**VILLAGE OF DOWNERS GROVE
REPORT FOR THE VILLAGE COUNCIL MEETING
DECEMBER 6, 2011 AGENDA**

SUBJECT:	TYPE:	SUBMITTED BY:
Special Use for 160 Ogden Avenue	<ul style="list-style-type: none"> Resolution ✓ Ordinance Motion Discussion Only 	Tom Dabareiner, AICP Community Development Director

An ordinance has been prepared for special use approval for a drive-through addition to an existing restaurant at 160 Ogden Avenue.

SUBJECT:	TYPE:	SUBMITTED BY:
PC-18-11 160 Ogden Avenue	Special Use for a drive-through window	Stan Popovich, AICP Planner

SITE / UTILITY PLAN:

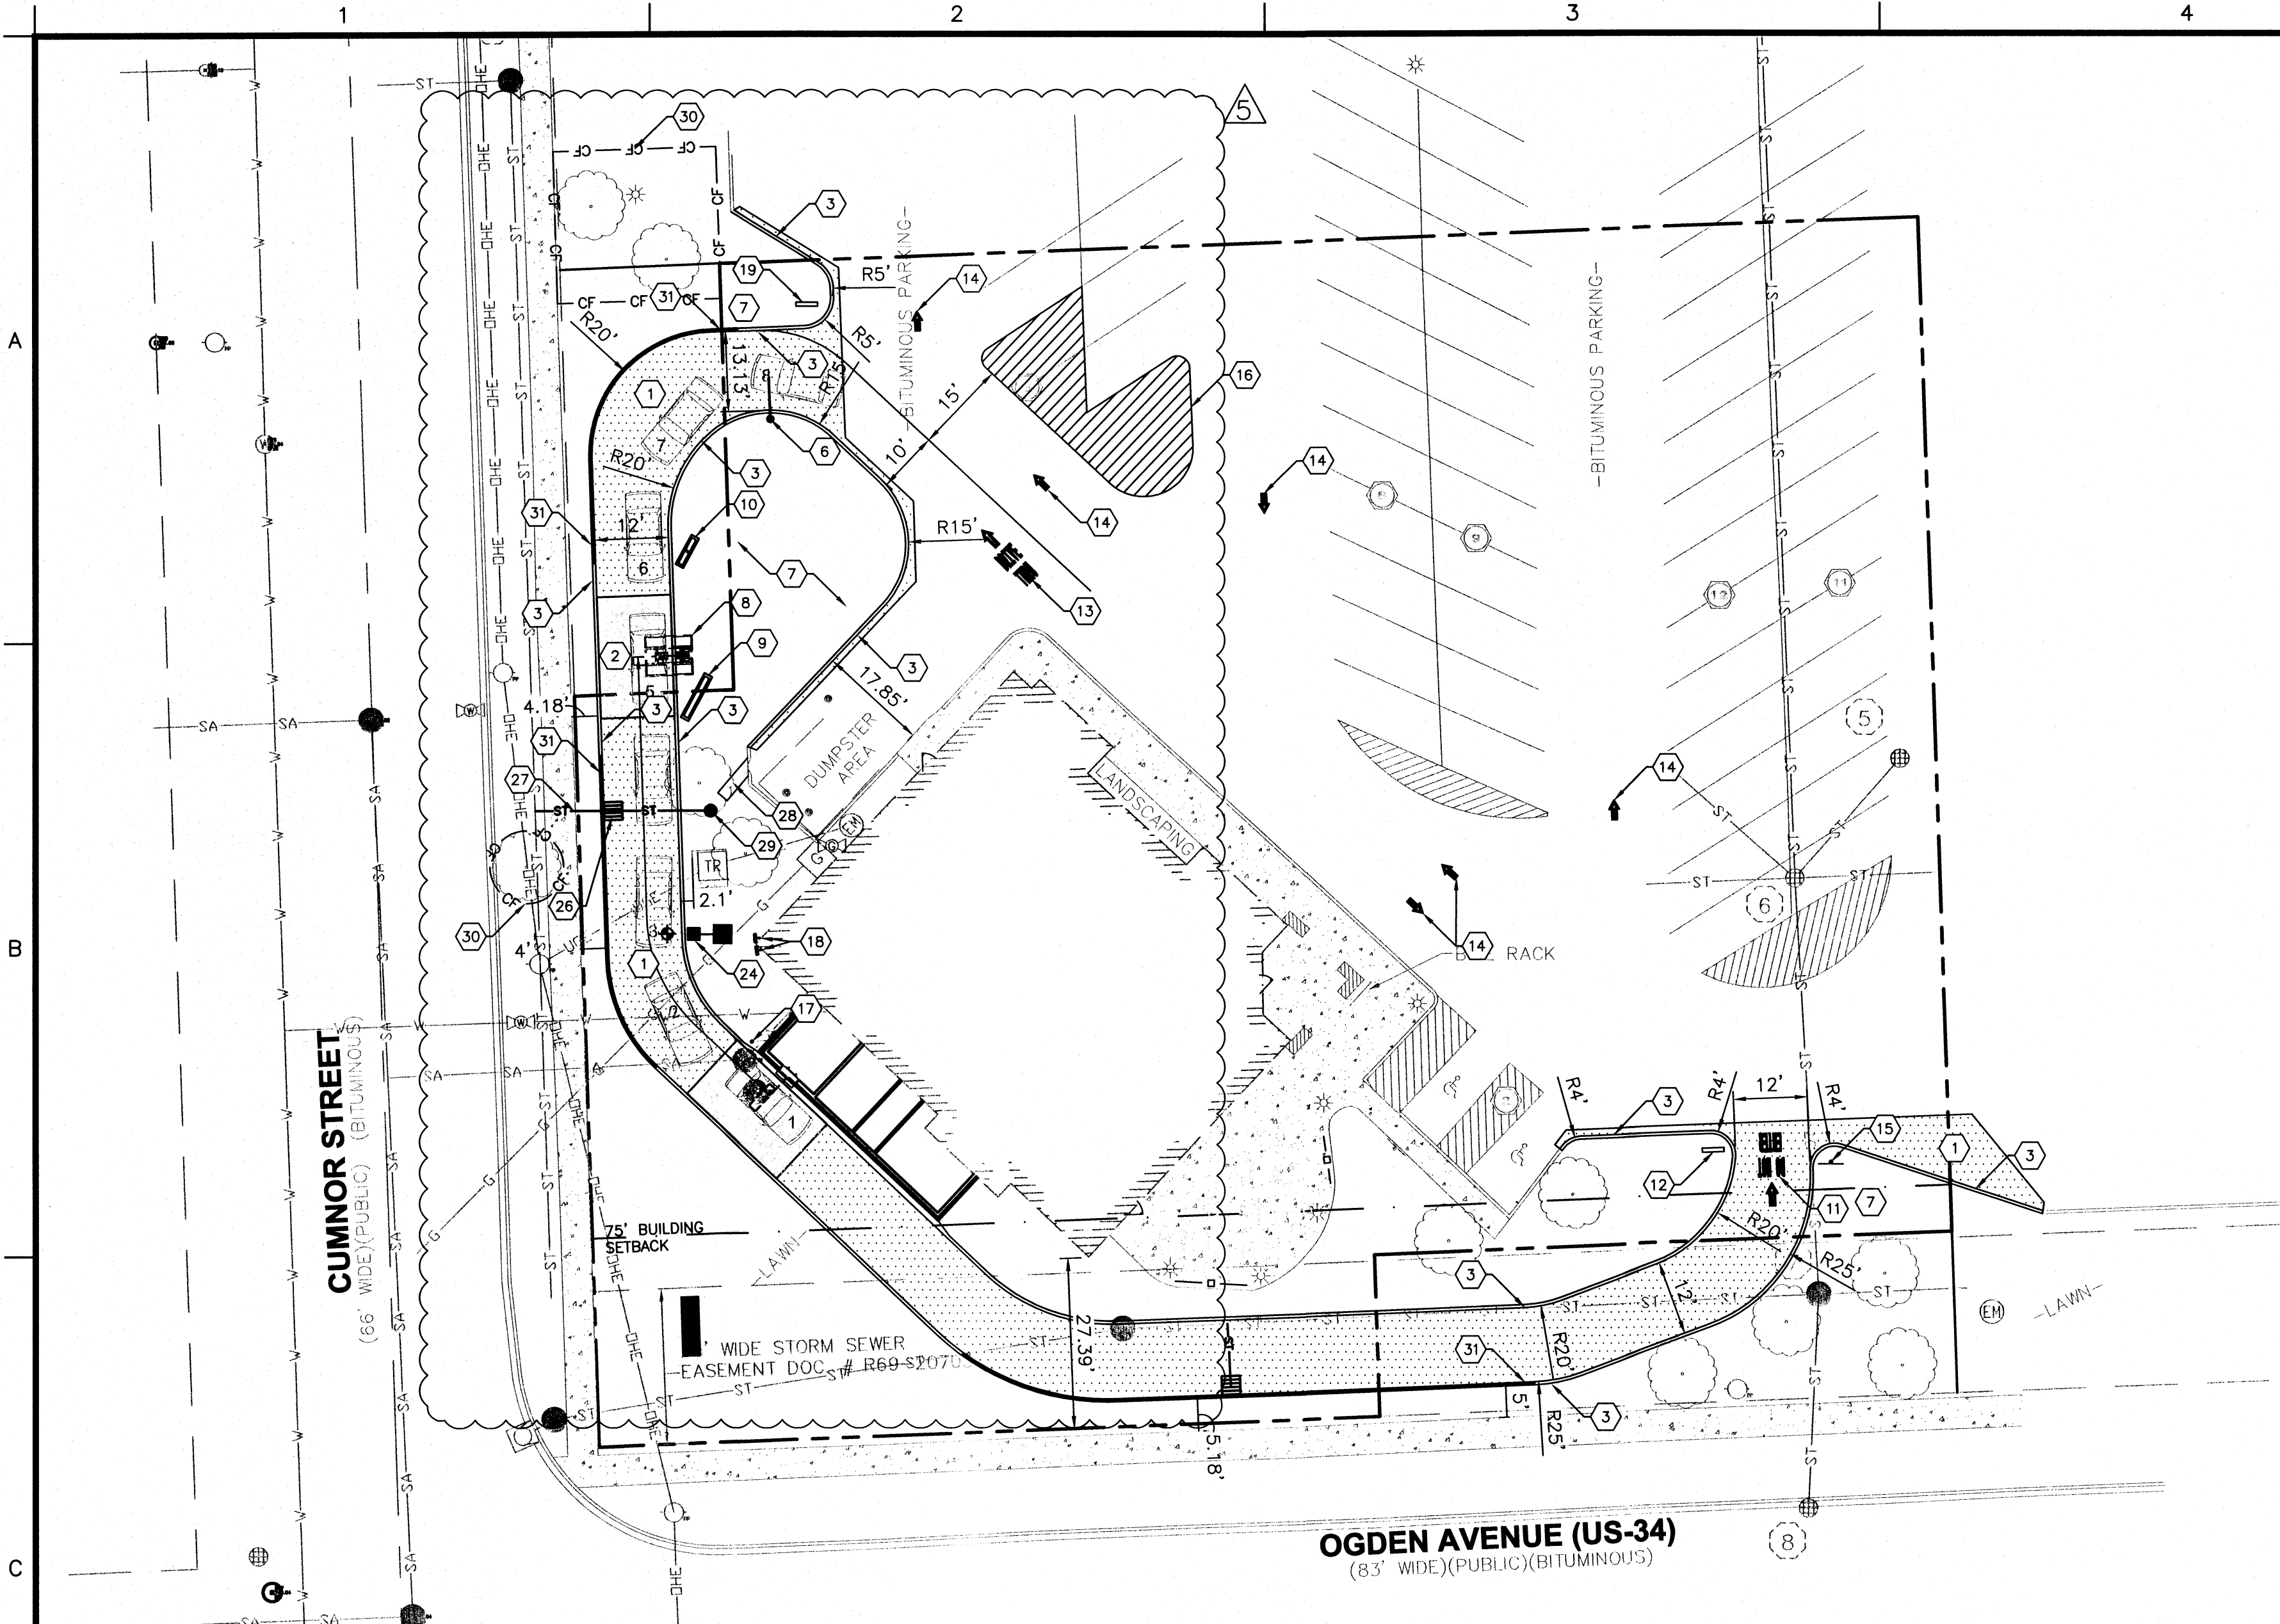
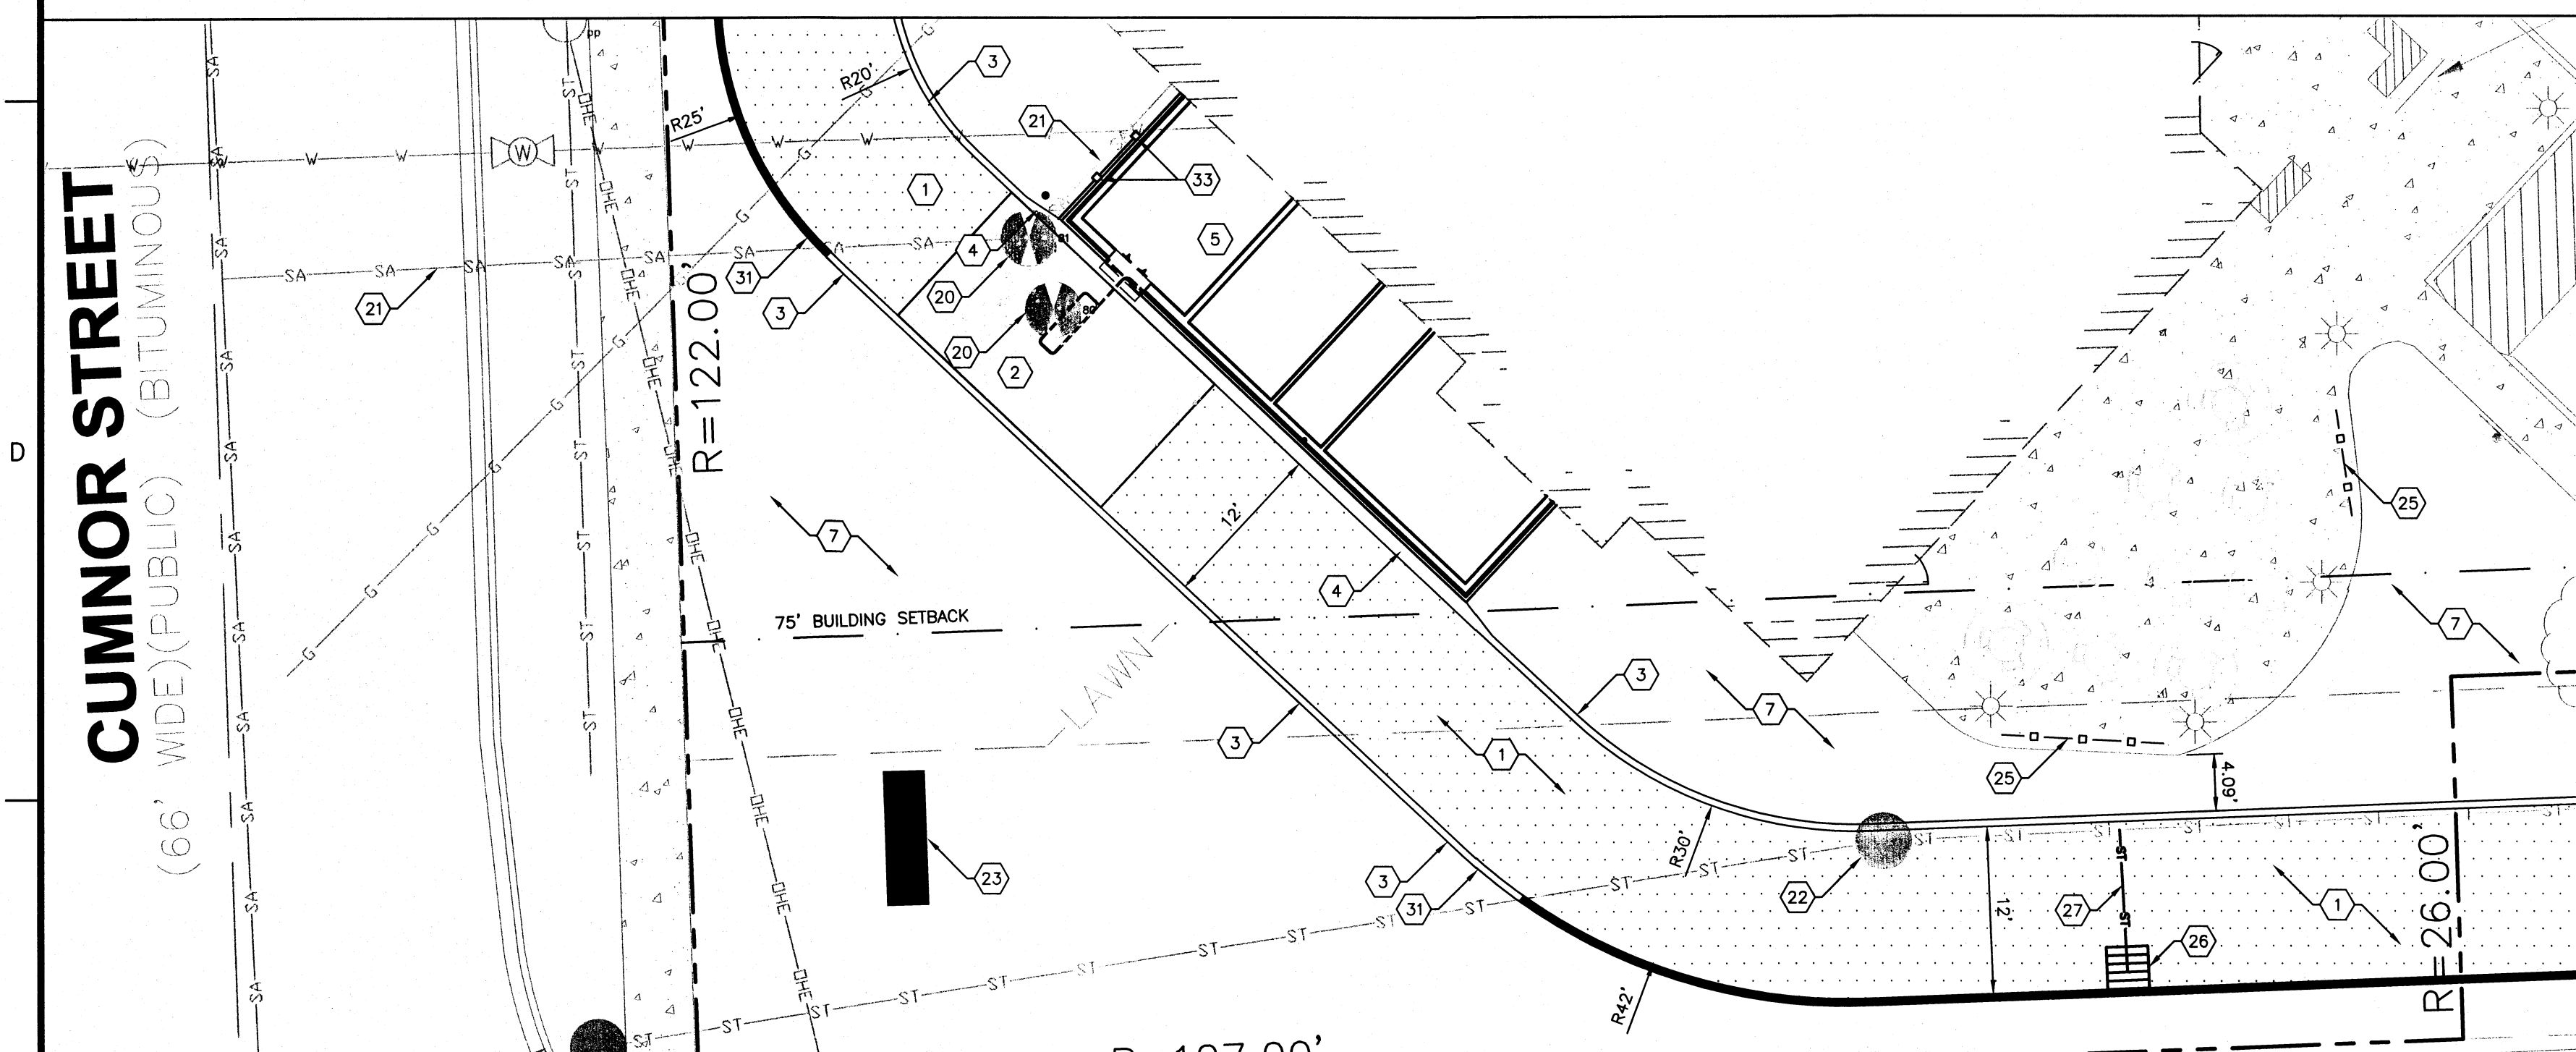
This item was discussed at the August 9, 2011 Village Council meeting. Staff recommends approval on the December 6, 2011 Active Agenda. During the meeting, the Village Council expressed concerns with regard to the safety of the proposed drive-through location. The petitioner has revised the site plan to address the Council’s comments. The revisions are as follows:

- The drive through lane adjacent to Ogden Avenue is now 5.18 feet from the sidewalk. The original proposal indicated a 2.5-foot setback from the sidewalk. This modification provides additional room for landscaping and buffering

- The drive through lane adjacent to Cumnor Road would be 4.2 feet east of the existing public sidewalk. The original proposal indicated a 2.5-foot setback from the sidewalk.

- Barrier curbs (approximately 250 feet) would be constructed to provide additional protection for pedestrians on the adjacent public walks.
- Additional landscaping, in the form of a continuous hedge row, is proposed for the area between the drive through lane and the adjacent sidewalks. The landscaping would be 18-24 inches at planting and would have a mature height of 3-6 feet with a spread of 3-5 feet. Typical truck, van and SUV headlight heights range from 26-41 inches.

- The proposed drive through exit point would be relocated east to eliminate potential conflicts between the existing handicap parking spaces and the exit lane.

- The proposed entry to the drive-through would be relocated slightly north to accommodate additional setback.
- The relocation of the entry and exit points would result in the elimination of eight additional parking spaces. The shopping center will have 410 parking spaces where 388 are required.

Landscaping Plan

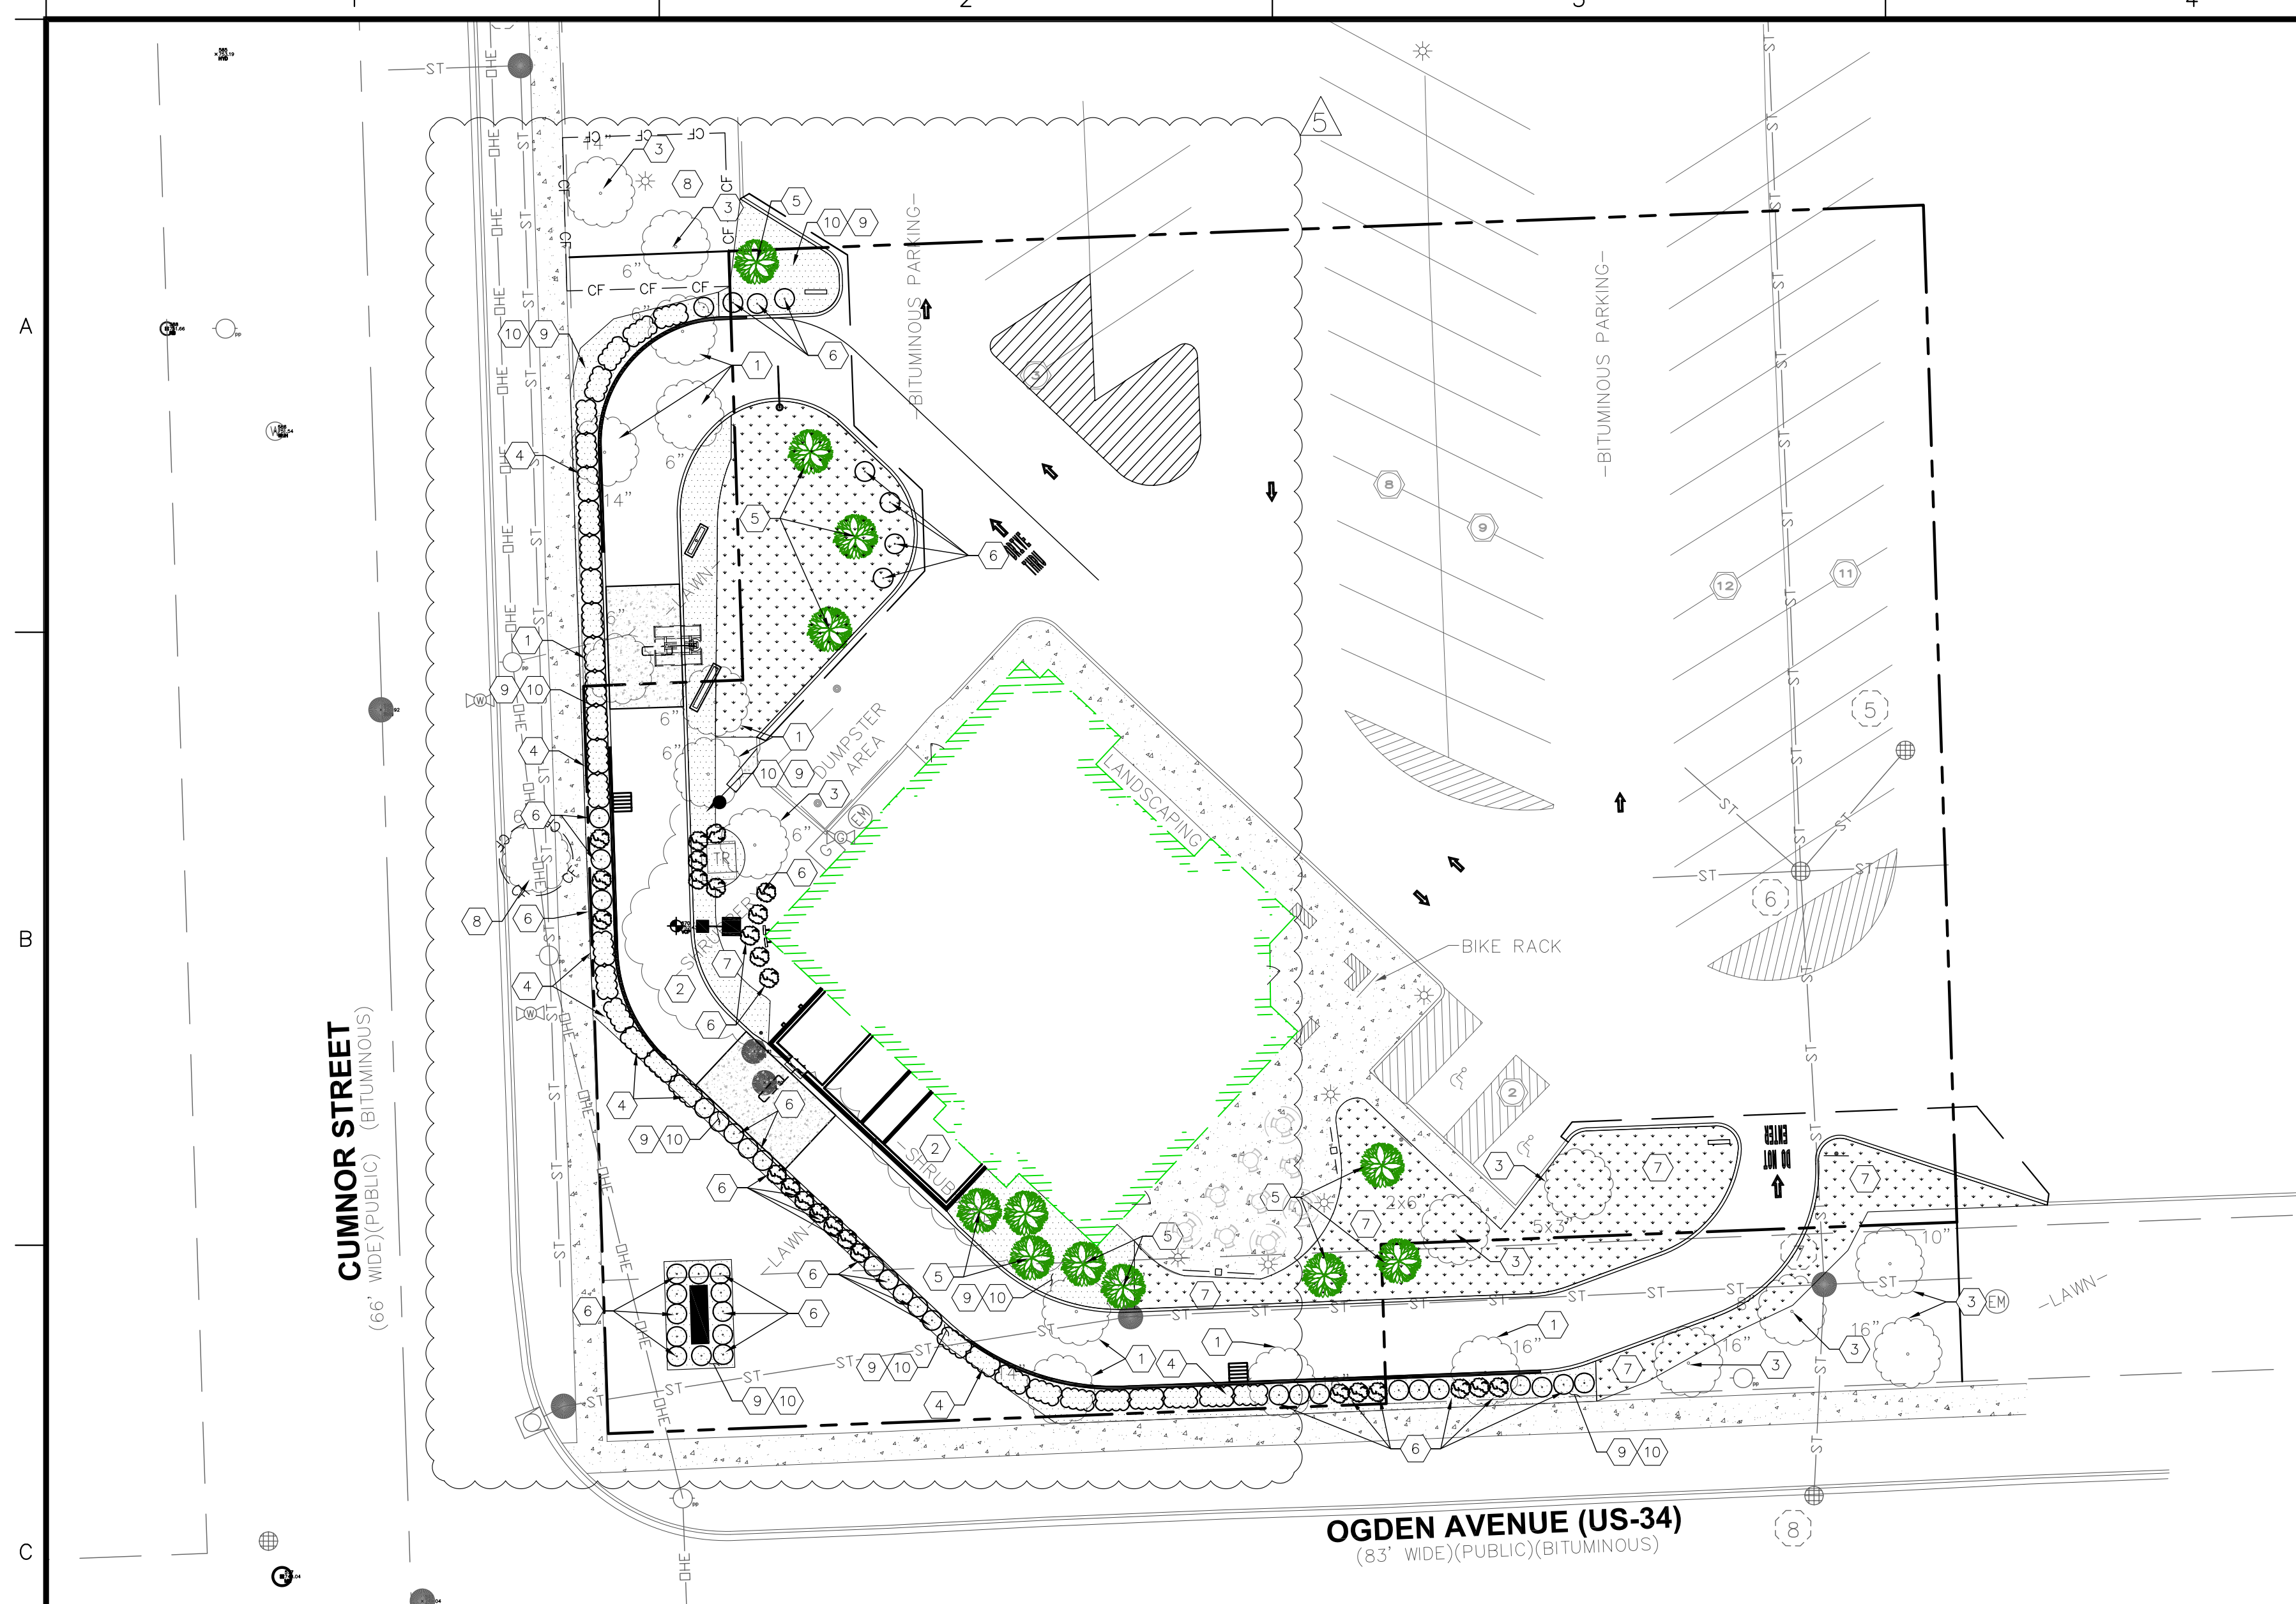
The Plan Commission considered the petition at their July 11, 2011 meeting. The Plan Commission expressed concerns regarding the proximity of the drive-through lane to the sidewalks along Ogden Avenue and Cumnor Road and the potential for headlights to shine into the adjacent rights-of-way. The petitioner addressed these concerns as follows: the installation of a nine-inch barrier curb along portions of the drive through lane to provide an additional safety barrier and the installation of an evergreen hedge row to eliminate headlights shining into adjacent rights-of-way. Staff believes these modifications will address the Plan Commission's concerns.
